Transport
Roads & Maritime
Services

**EXHIBITION OF DRAFT LOCAL ENVIRONMENTAL PLAN AND DRAFT
DEVELOPMENT CONTROL PLAN 2011**

DRAFT CITY OF RYDE LOCAL ENVIRONMENTAL PLAN 2011

Roads and Traffic Authority

Victoria
Road (SP2)

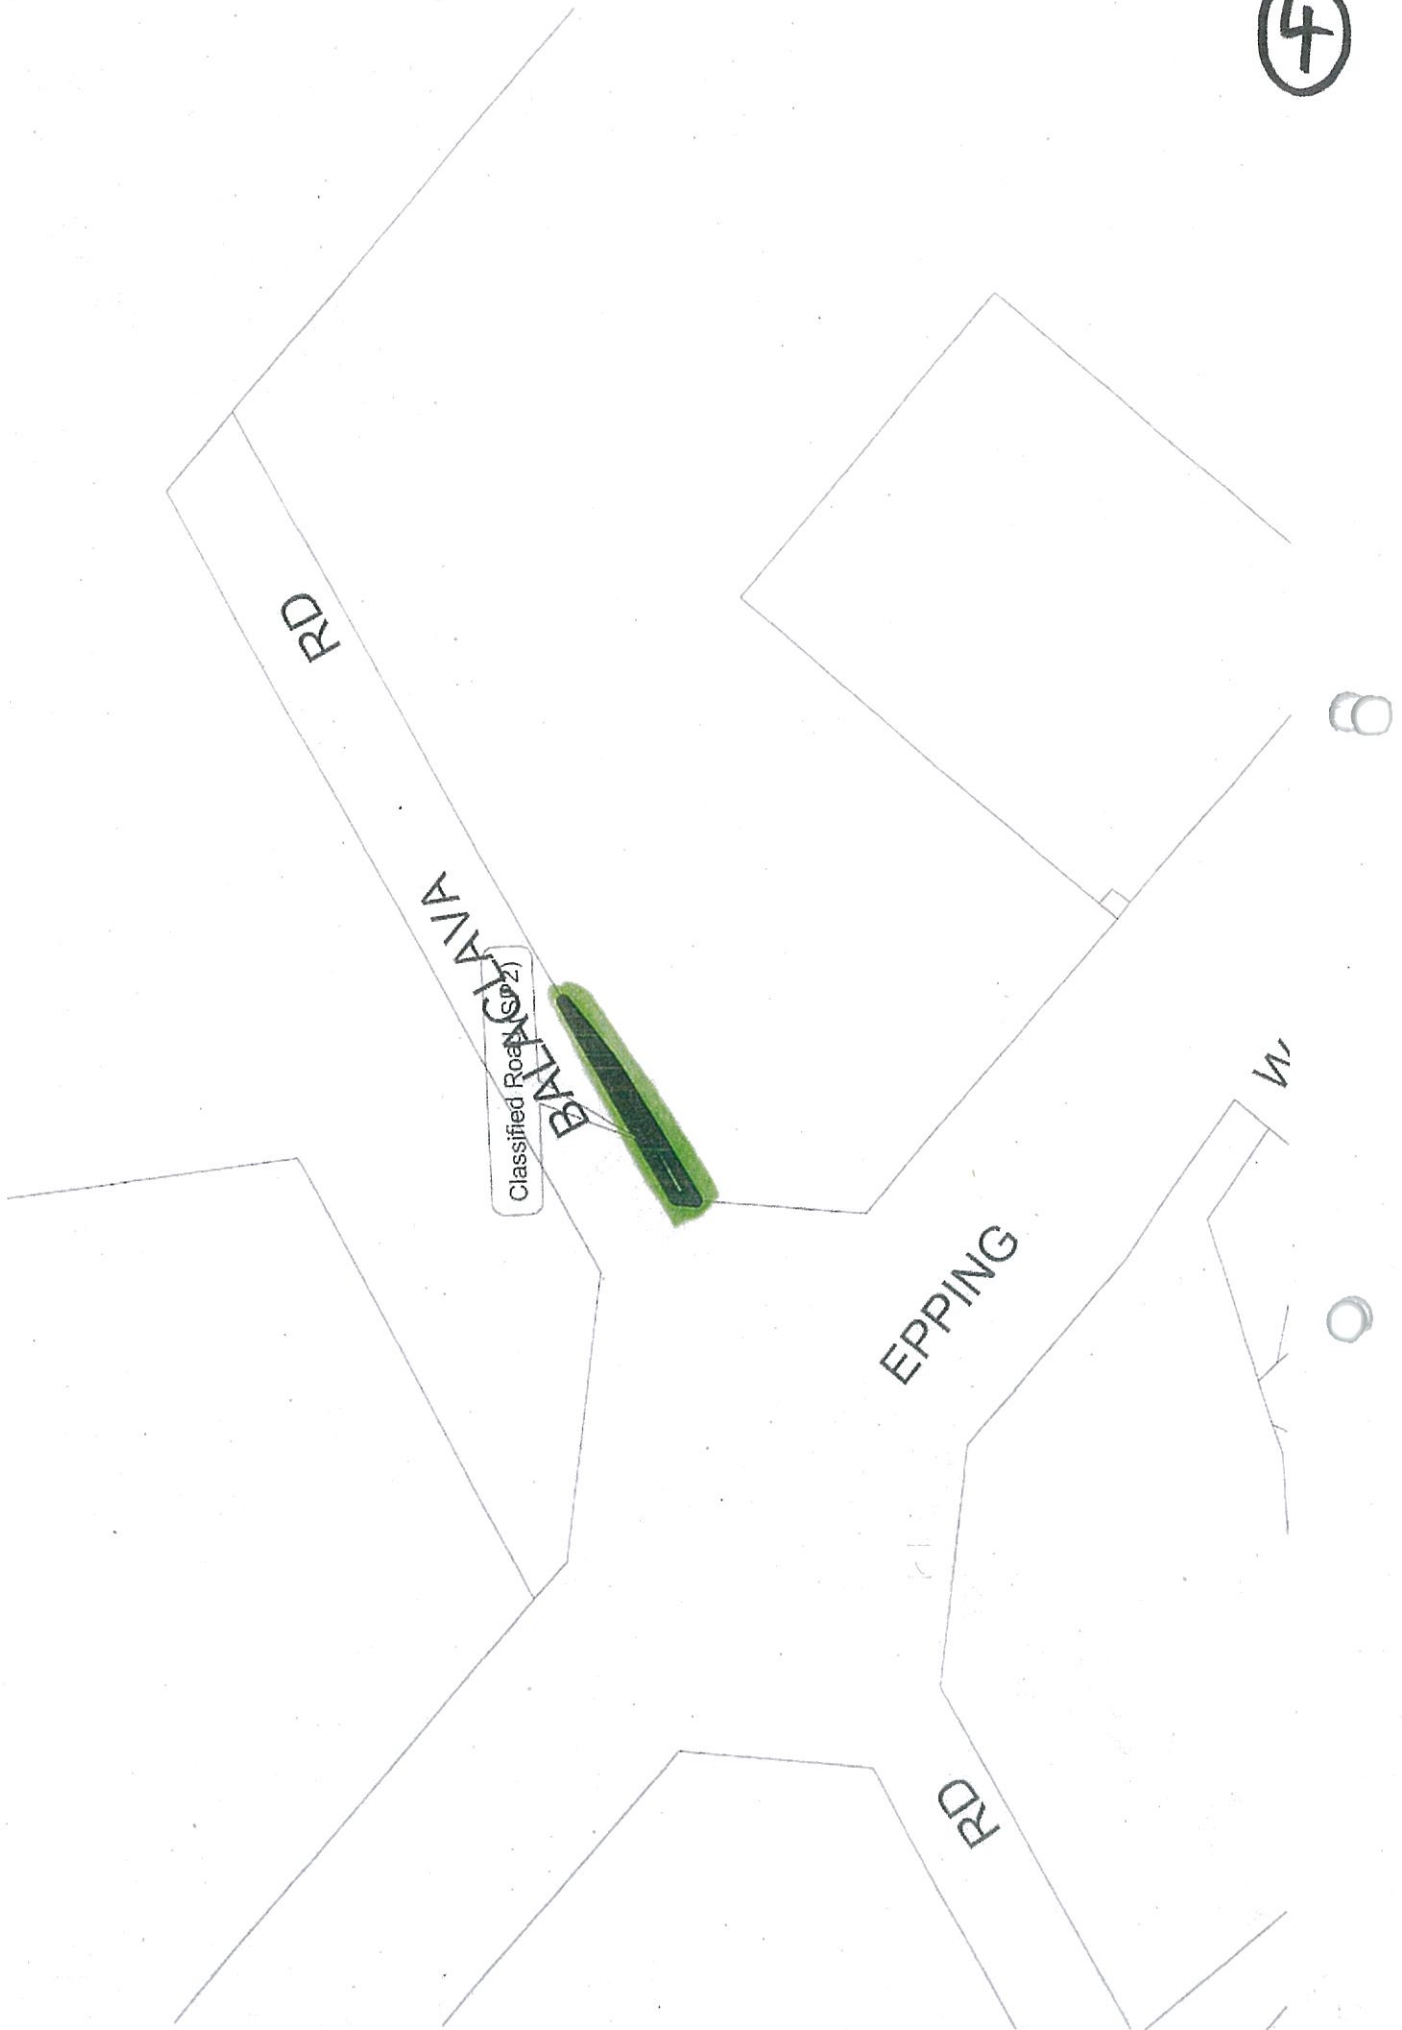
The strips of land coloured pink shall be shown as Classified Road (SP2) on the appropriate Land Reservation Acquisition Map as per the attachments:

1. M2 Motorway/Vimiera Road
2. Victoria Road between Northern Railway and Hermitage Street
3. The SP2 strip should be relocated to the corner of Victoria Road/Monash Road

④

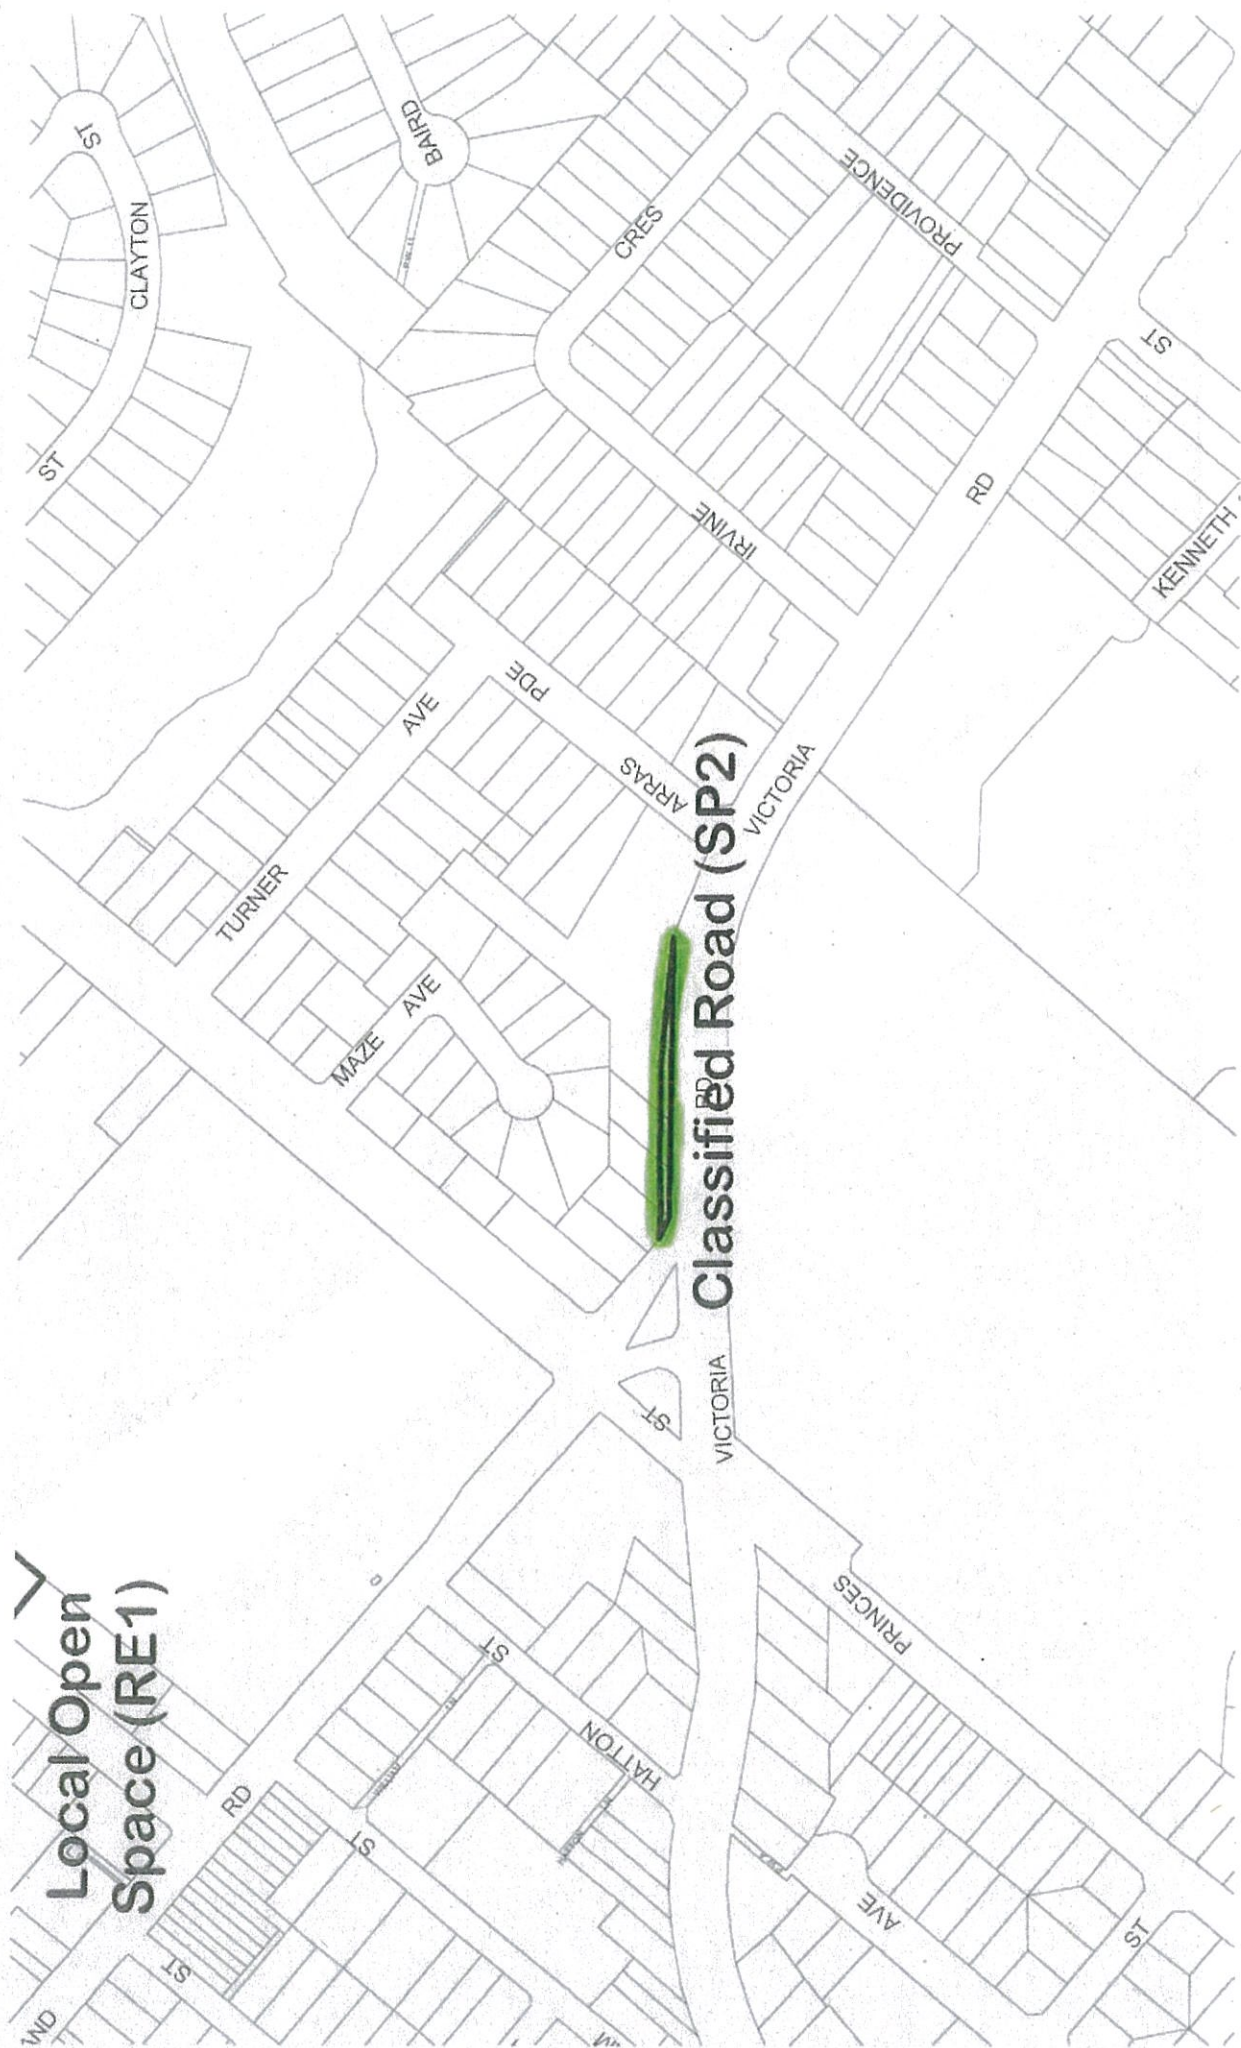
The strips of land shown in the attachments now owned by the RTA may be removed from the Land Reservation Acquisition Maps at:

4. Epping Road/Balaclava Road
5. Victoria Road/Blaxland Road

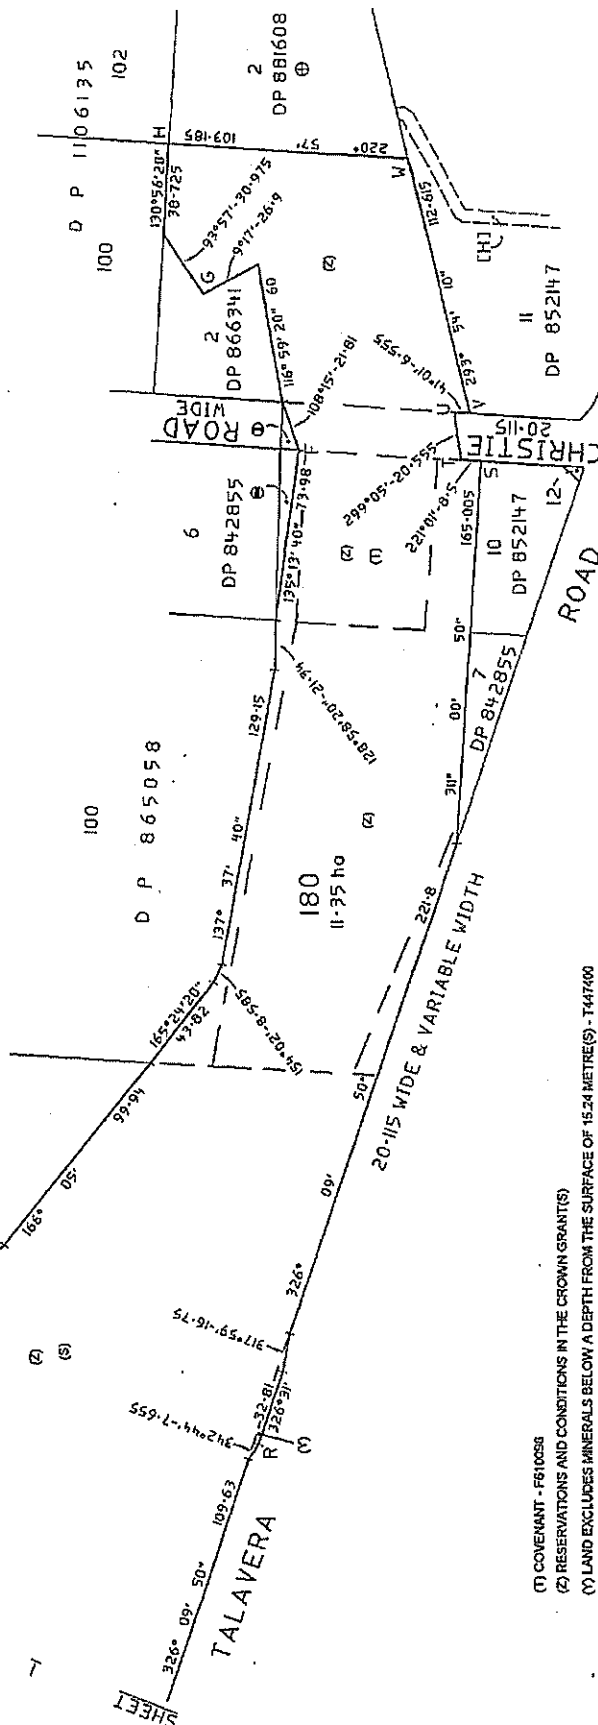
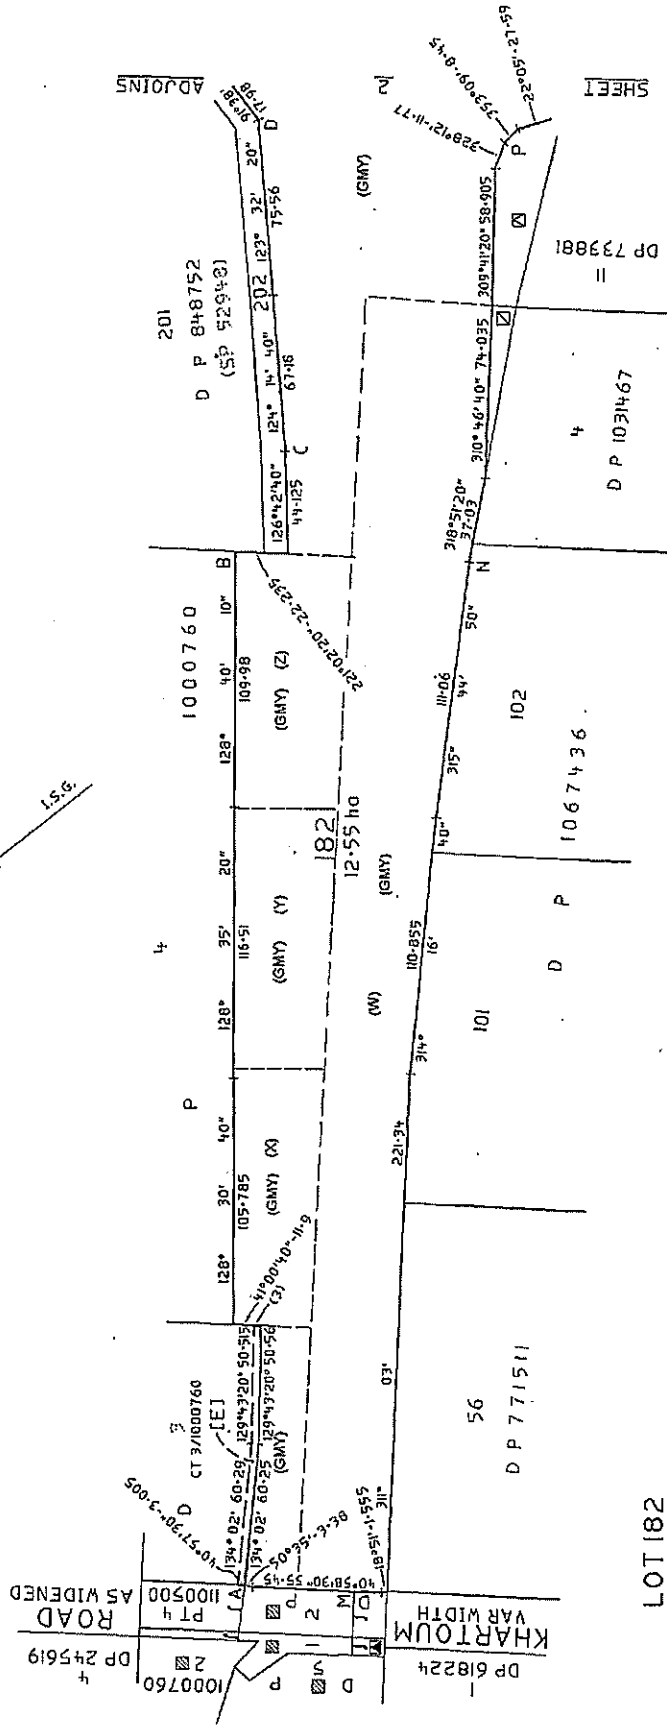
Per our recent discussion, please refer the attachments which show marked up plans for boundaries to be amended on the M2 Motorway, on Council's draft zoning map. SP2 classified road zonings require either being reduced to or increased to the boundaries shown. As discussed, this is not yet a formal submission - further (hopefully) minor changes need to be addressed on Regional road boundaries, zonings on RTA owned residue land parcels and also a check of the Land Reservation Map.
